MFN 06-261

Docket No. 52-010

**Subject: Response to Portion of NRC Request for Additional Information
Letter No. 44 Related to ESBWR Design Certification Application –
Reactivity Control System – RAI Numbers 4.6-24 through 4.6-26,
4.6-29 through 4.6-33, 4.6-35 through 4.6-37**

Enclosure 1

Typical Core Plate to Shroud Connection

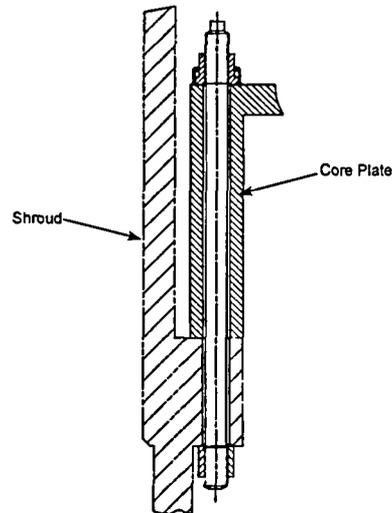
With regard to blowout support, DCD Tier 2, Section 4.6.1.2.2 states, "...after the interconnected assembly of the housing, CRD and [control rod guide tube] CRGT moves down a short distance, the flange at the top of the CRGT contacts the core plate, stopping further movement of the assembly." Whereas, DCD Tier 2, Section 4.1.2.1.2 states, "Each guide tube, with its orificed fuel support, bears the weight of four assemblies and is supported on a CRD penetration nozzle in the bottom head of the reactor vessel."

(a) Describe in further detail the support of the fuel assemblies and the core support plate. Include in your response, address thermal expansion and contraction of the reactor vessel and internals.

(b) Describe the design margin between the CRGT flange elevation and core support plate elevation. In your response, address (1) thermal expansion and contraction of the reactor vessel and (2) differential growth between the reactor vessel and CRGT.

(a) In addition to the description of the support of the fuel assemblies given in DCD Tier 2, Sections 4.1.2.1.2 and 4.6.1.2.2, further descriptions of the fuel supports and the core plate are given in Section 3.9.5.1. Schematic illustrations of the fuel support pieces are shown in Figure 3.9-4. The core plate that provides lateral support of the fuel is bolted to a ledge at the inside lower portion of the shroud as shown in the figure below.

The width of the gap between the flange at the top of the CRGT and the core plate as shown in DCD Tier 2, Figure 4.6-7 is determined to ensure that there will be no interference between the two components during any loading condition of the reactor. In calculating the required gap, the differential thermal expansion between the low alloy reactor vessel and the austenitic stainless steel shroud, core plate and CRGT are considered. Also, included in the calculation are the dilation of the vessel due to internal

pressure and the upward movement of the core plate due to the differential pressure across the core plate.

(b) The size of the gap between the CRGT flange and core plate will be determined upon completion of the detailed design of the reactor vessel and the core support structure. A margin comparable to that of earlier BWRs will be added to the calculated value to ensure that there will be no interference during any loading condition of the reactor.
